Development Permit Panel

Wednesday, May 27, 2020
3:30 p.m.

1. **DEVELOPMENT PERMIT 19-866690**
(REDMS No. 6433306)

PROPERTY LOCATION: 5491 No. 2 Road

NORTH ELEVATION

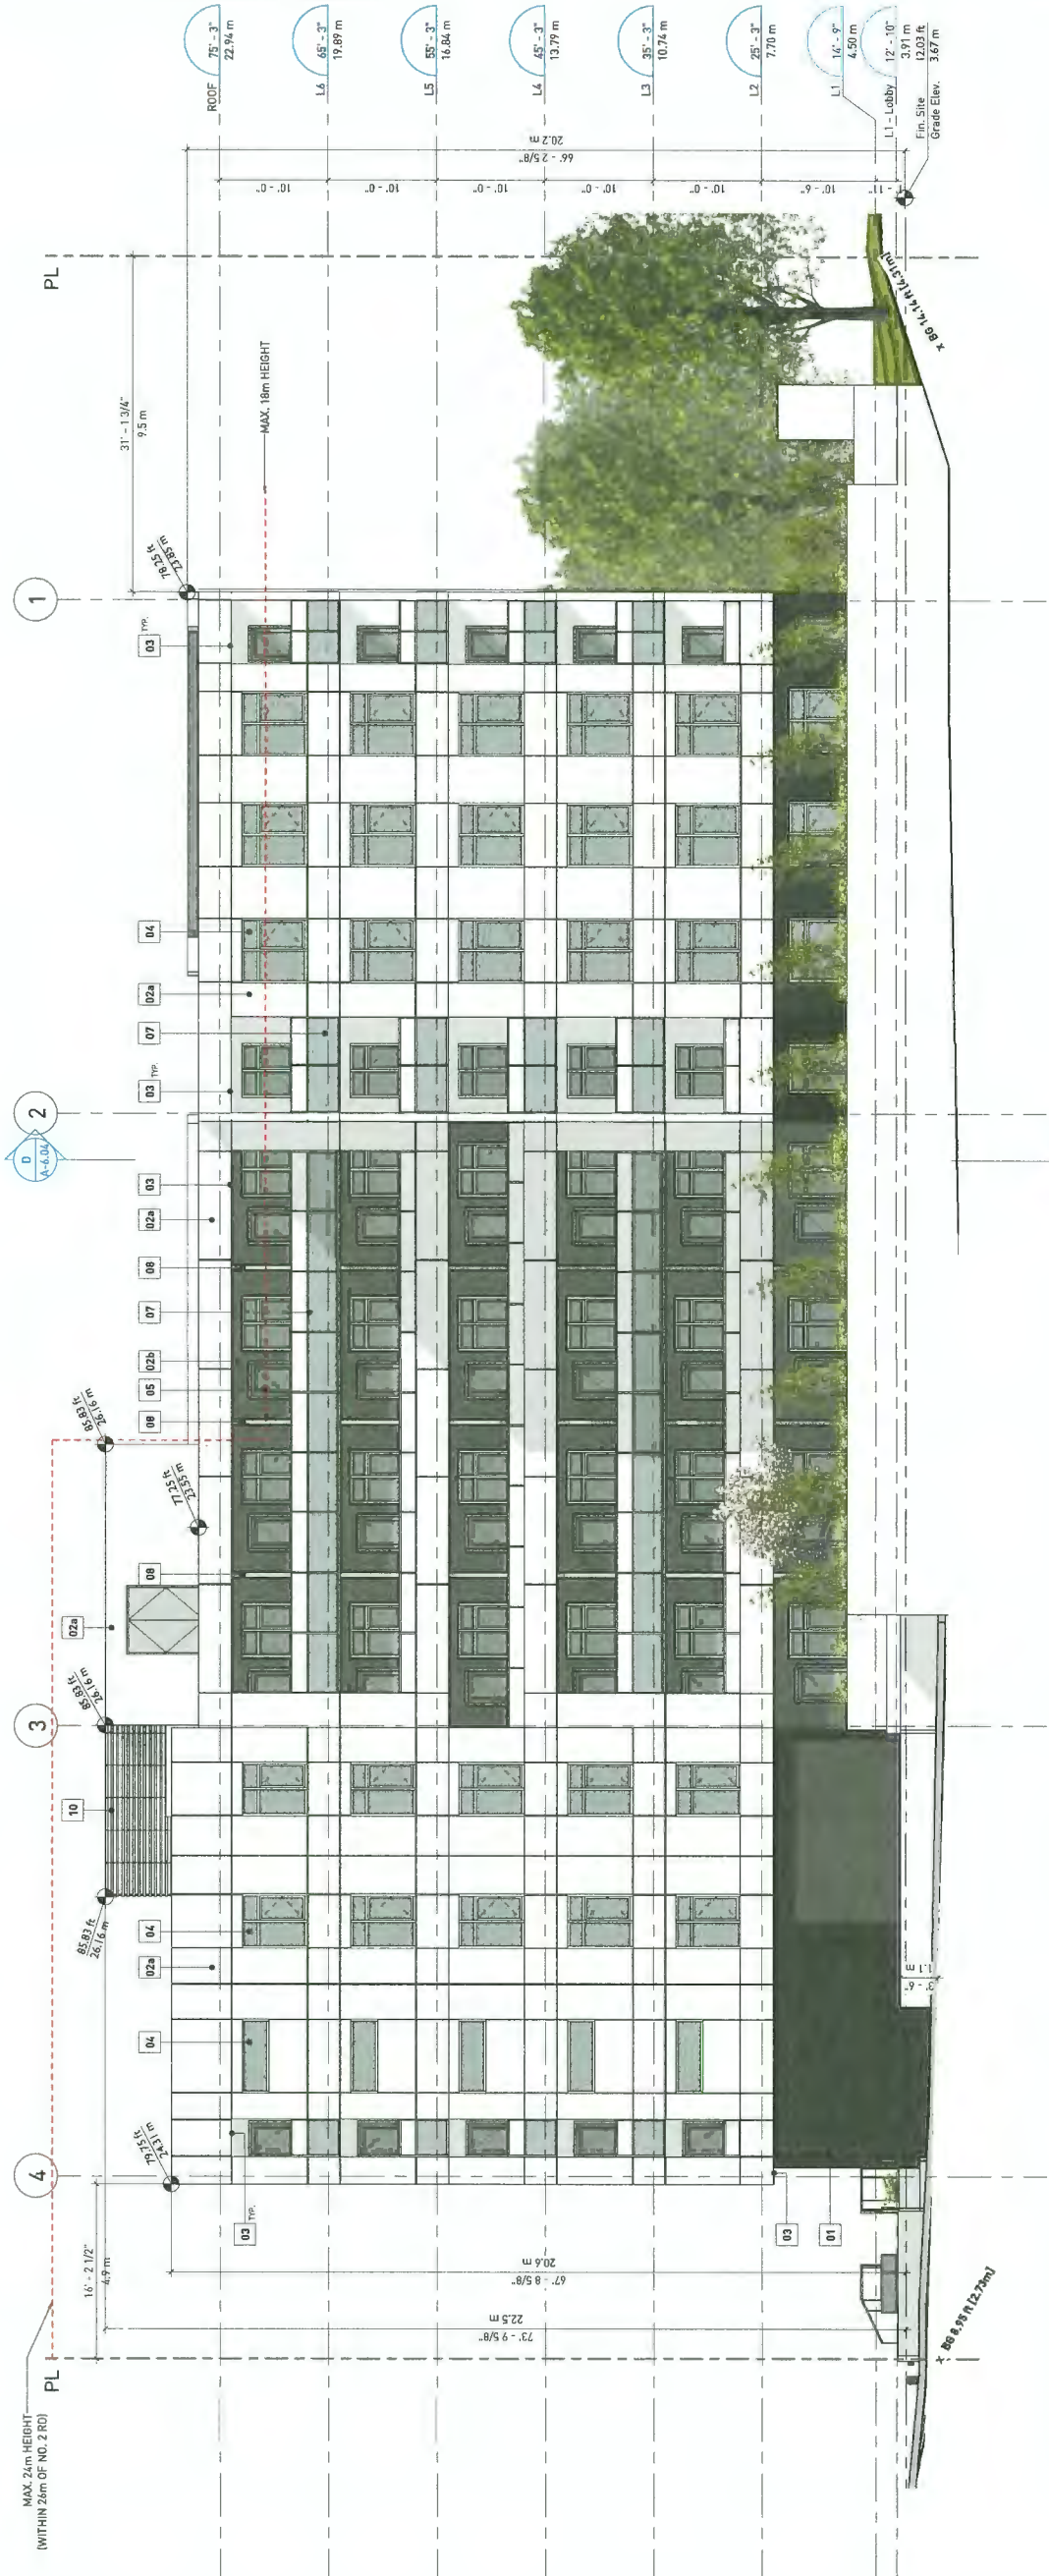
(ii) the building façade fronting No. 2 Road appears like a box and lacks articulation to create a gateway character; the west and south facades are more successful – ***Reviewed. The site directly to the North will provide the gateway view from the No. 2 Road bridge approach, block the view of our building. The design focuses on the South and West views from the public pathway which will be preserved and provides differentiated elevation designs but not overly decorative***

SHADOW STUDIES

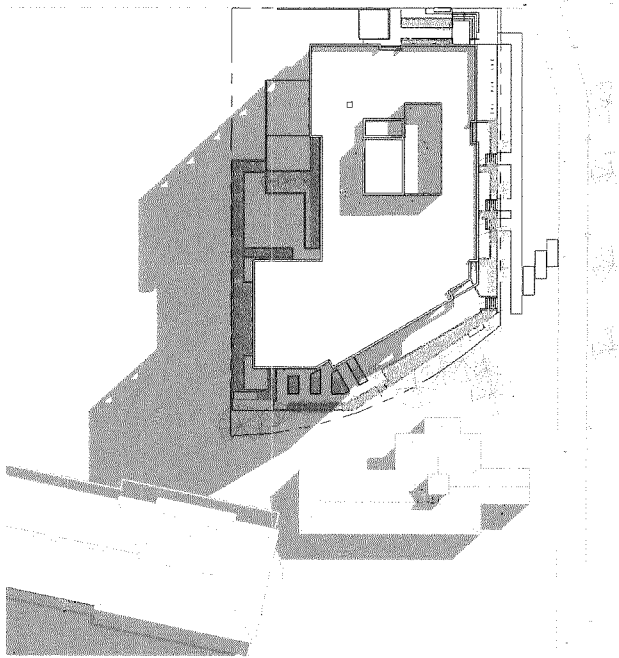
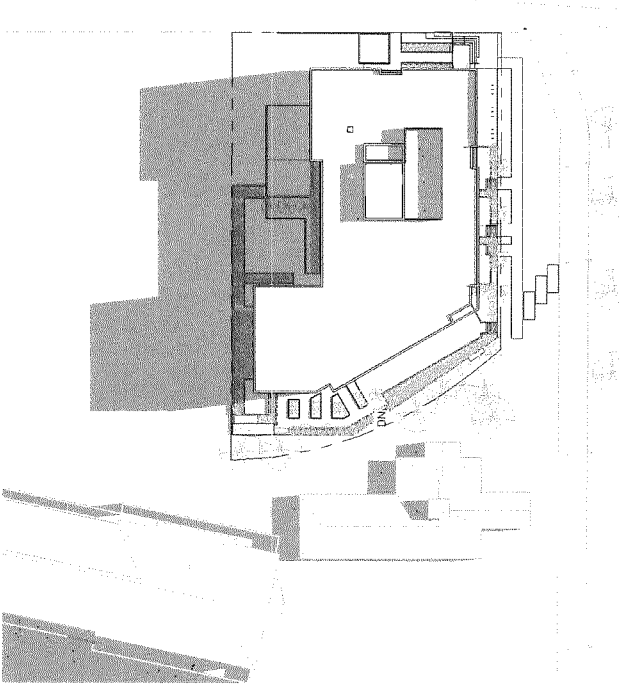
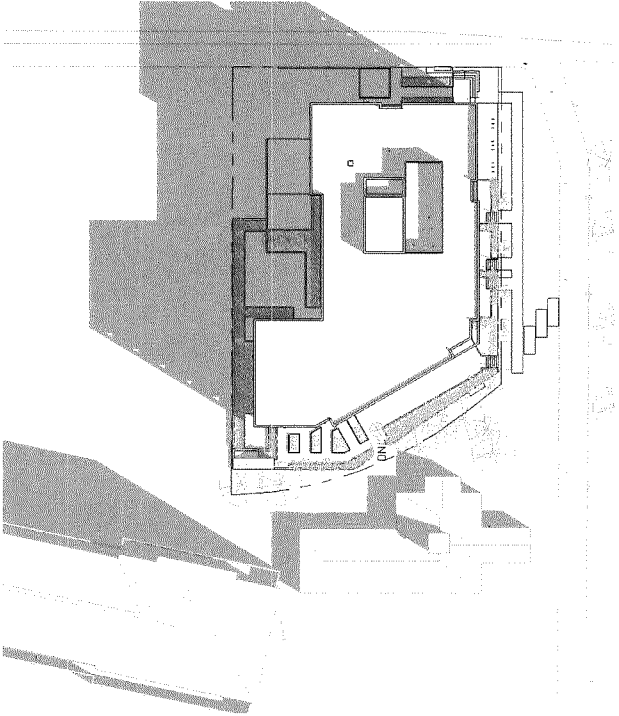
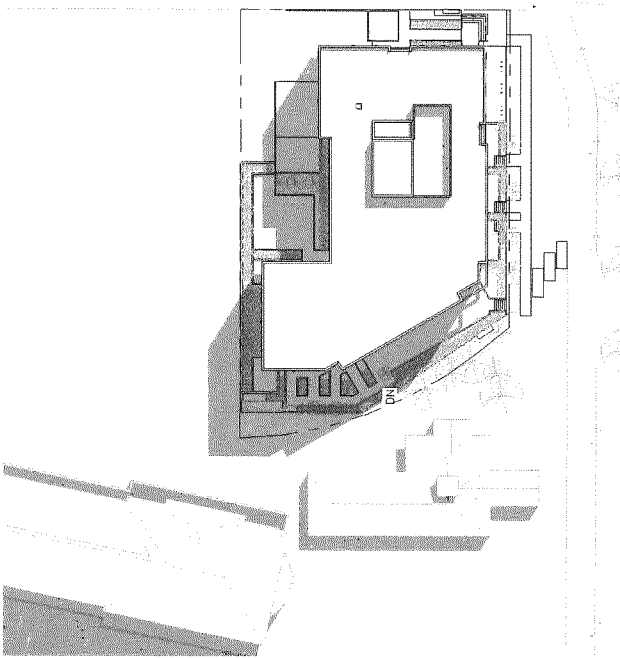
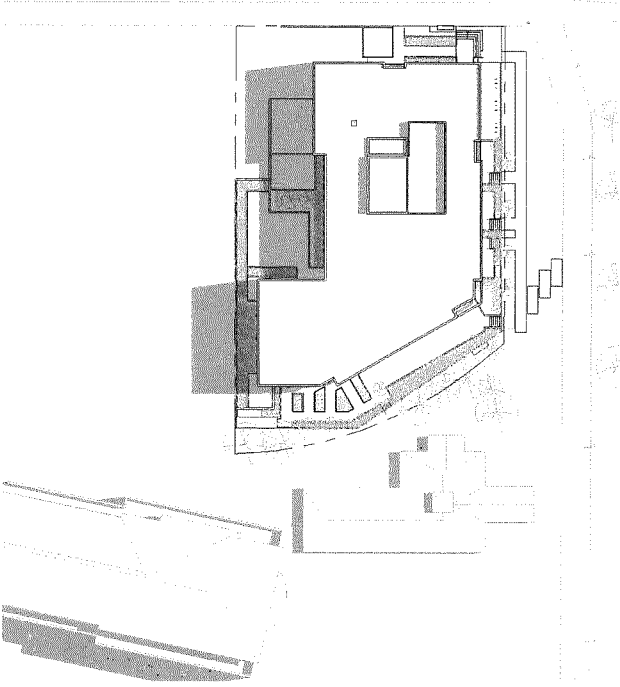
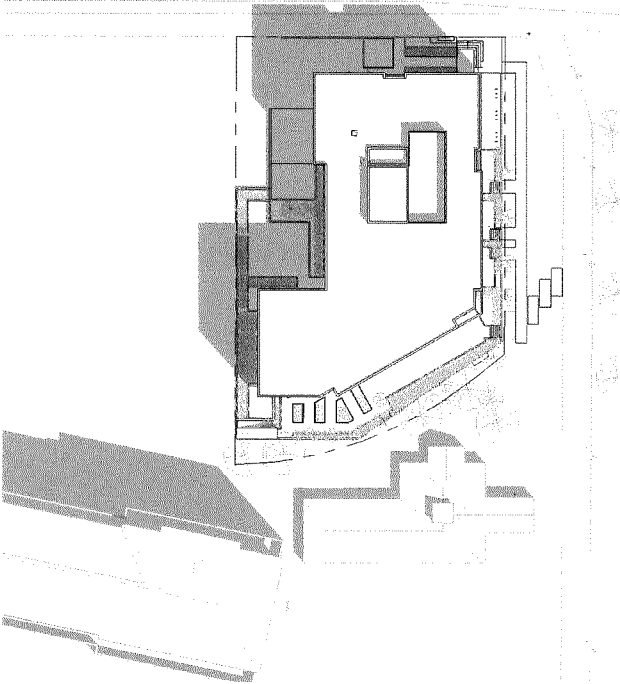
- e) Concerns about neighbourhood impact of building height obstructing views and sunlight – ***The proposal complies with the overall height permitted in the existing zoning, with increased height in a portion of the roof area to allow the top floor to be a full size floor, the same size as lower floors. The applicant has submitted shadow analysis that demonstrates that the proposal will only have a minor impact on existing neighbouring development. The shadow analysis is included as a reference plan in the DP plans.***
